NUMBER
DEP15860

Addendum Number: 02

DEP15860
Cherokee Complex
Addendum #, 2

CHEROKEE COMPLEX
McDOWELL COUNTY, WV

BENCH CROSSING (3) E10

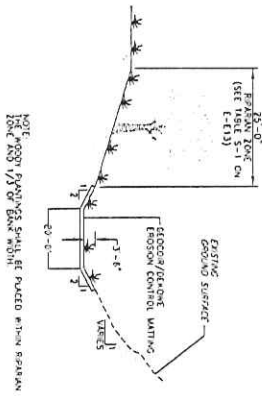
Item 12: Revised Sheet E-10 is included to show a grout anchor detail and a bench crossing detail.

CHANNEL DETAILS

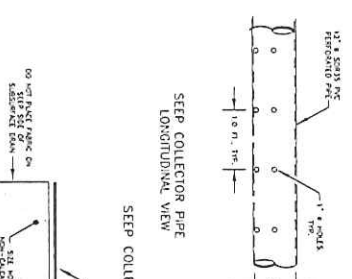
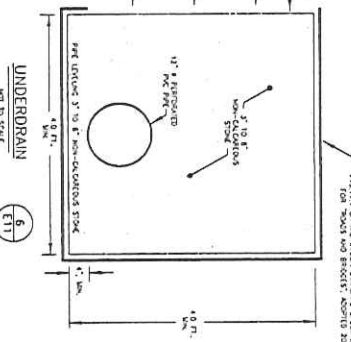
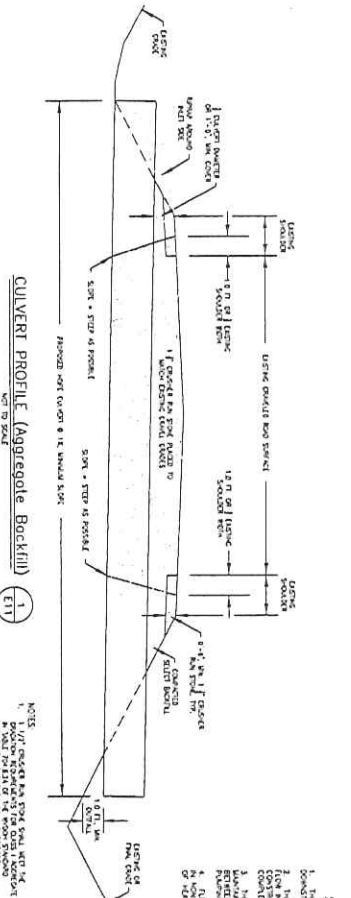
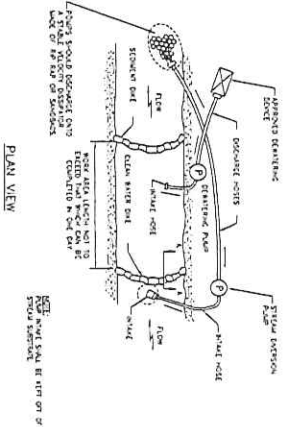
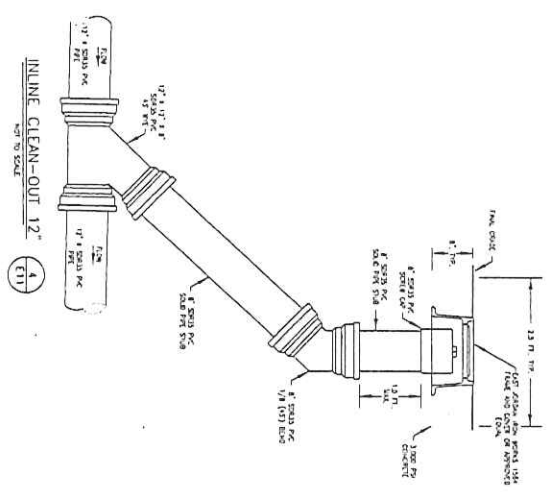
Item 9: The rip rap lining thickness for ditches has been modified to 18-inches. A revised channel chart is included on Sheet E-10.

CHANNEL SUMMARY									
CHANNEL	TYPE	STATION	DEPTH (FT. MIN.)	SIDE SLOPES	AVG. SLOPE (%)	LINING	LINING THICKNESS	TOP WIDTH (FT. MIN.)	BOTTOM WIDTH (FT.)
1	VEE	100+00.0 - 101+75.0	3	2:1	0.5	GRADED	18	12	0
	VEE	101+75.0 - 102+55.0	3	2:1	3.4	GRADED	18	12	0
	VEE	102+55.0 - 103+20.0	3	2:1	11.2	GRADED	18	12	0
	VEE	103+20.0 - 103+75.0	3	2:1	7.2	GRADED	18	12	0
	VEE	103+75.0 - 104+50.0	3	2:1	15.0	GRADED	18	12	0
	VEE	104+50.0 - 105+15.0	3	2:1	30.0	GRADED	18	12	0
	VEE	105+15.0 - 106+48.6	3	2:1	3.0	GRADED	18	12	0
2	PIPE	200+00.0 - 200+26.1	3	2:1	67.0	42" PIPE	18	12	0
	VEE	201+02.8 - 201+20.5	3	2:1	2.0	GRADED	18	12	0
	VEE	201+20.5 - 202+31.1	3	2:1	40.0	GRADED	18	12	0
	VEE	202+31.1 - 203+35.9	3	2:1	0.8	GRADED	18	12	0
3	VEE	300+00.0 - 304+25.0	3	2:1	6.5	RIPRAP	18	12	0
	VEE	304+25.0 - 308+20.0	3	2:1	2.5	RIPRAP	18	12	0
	VEE	308+20.0 - 309+80.0	3	2:1	3.5	RIPRAP	18	12	0
	VEE	309+80.0 - 311+60.0	3	2:1	5.5	RIPRAP	18	12	0
	VEE	311+60.0 - 312+80.0	3	2:1	7.0	RIPRAP	18	12	0

- NOTES
1. EXTEND GROUT ANCHOR UNLESS THE FULL WIDTH OF THE CHANNEL AS SHOWN IN THE CROSS SECTION VIEWS
 2. INSTALL GROUT ANCHOR AT THE JUNCTION OF CHANNEL
 3. AFTER EXCAVATING THE GROUT ANCHOR TO THE DIMENSIONS SHOWN, PLACE GROUT IN THE EXCAVATION
 4. 7" - TOP WIDTH - 4 FT
 5. 7" - NEW GROUT - 0.3 FT
 6. 7" - NEW GROUT - 0.3 FT
 7. * - THICKNESS = 18" IN

MISCELLANEOUS DETAILS

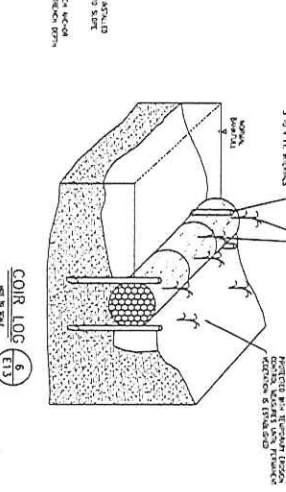
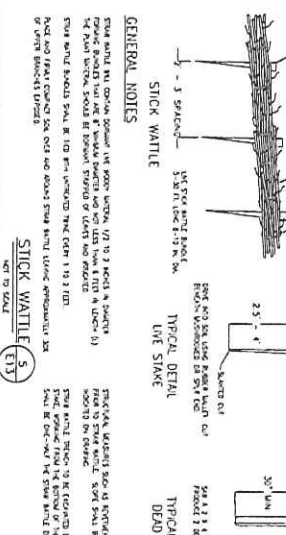
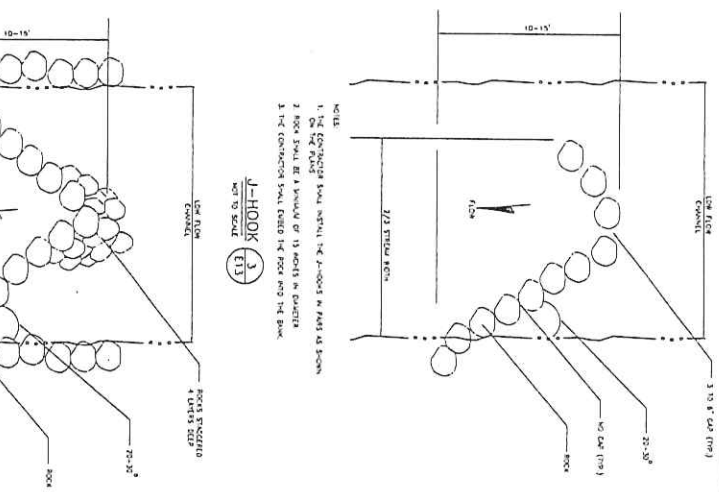
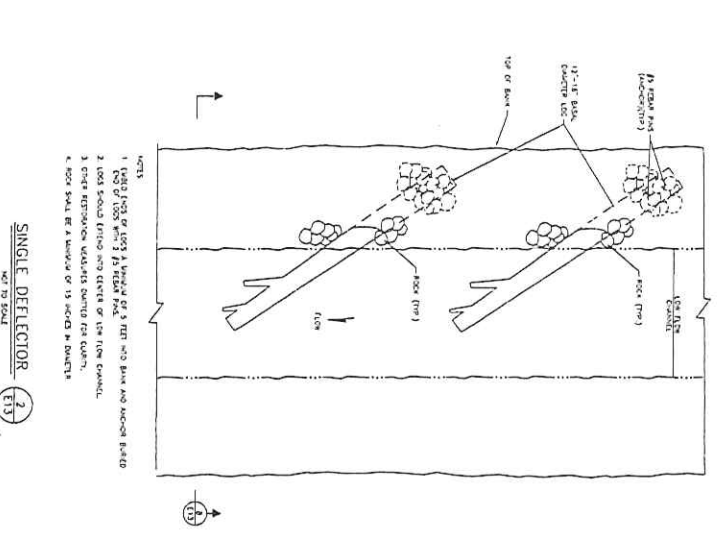
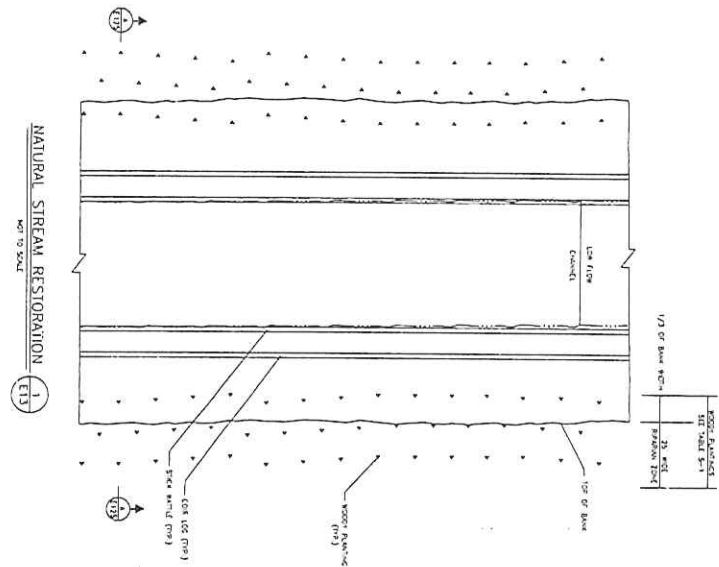
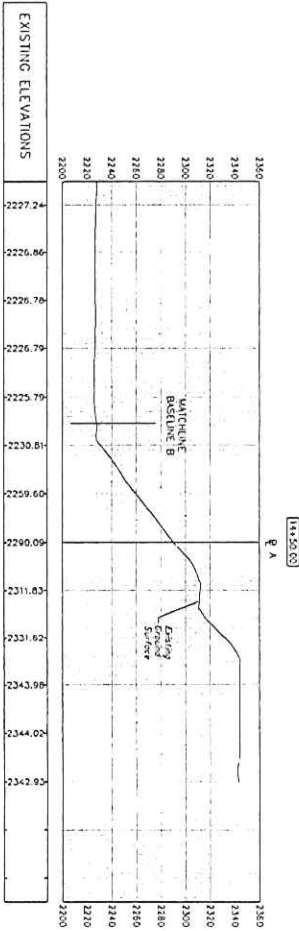
Item 10: Revised Sheet E-13 is included to show the placement of the stick wattles and coir logs. Additional details for the stick wattles and coir logs have been added to Sheet E-13. Sheet E-13 also includes Table S-1, which provides further details on plant materials for riparian vegetation. The percentage of each seed is shown on the table – to be applied at two pounds per 1000 sf. The plantings are to be placed at 10-foot spacing in all directions. A variety of the plants should be utilized, based on their availability. An approximate equal percentage of each variety should be utilized. The Contractor shall submit the proposed mixture to the Engineer for review and approval.

Item 14: Revised Sheet E-13 is included to show the placement of the stick wattles and coir logs. Additional details for the stick wattles and coir logs have been added to Sheet E-13.

**TABLE S-1
SPECIFICATIONS FOR PLANT MATERIALS FOR STREAM RESTORATION**

BASELINE "A"
CROSS SECTIONS

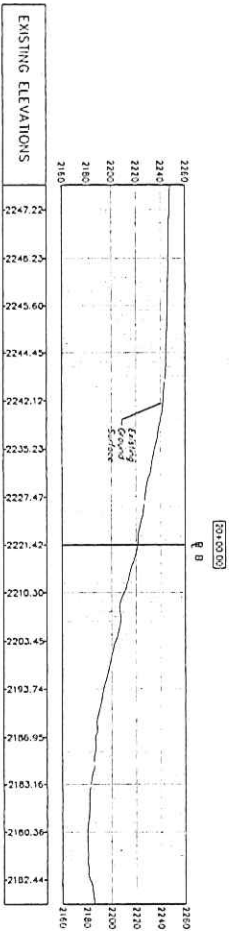
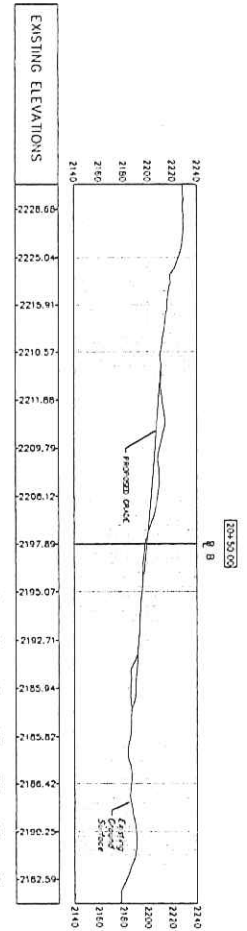
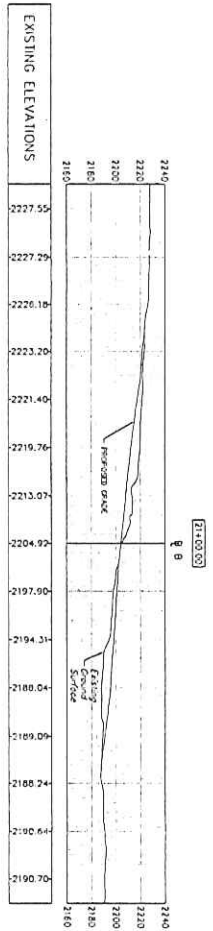
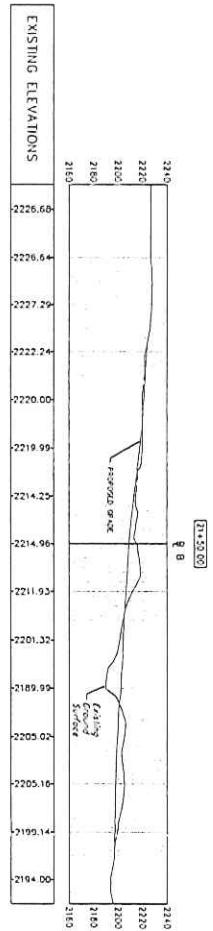
Item 7: Revised Sheets E15-E20 have been included to show the cross sections for Baseline A and Baseline B, and their match lines, in relation to each other.
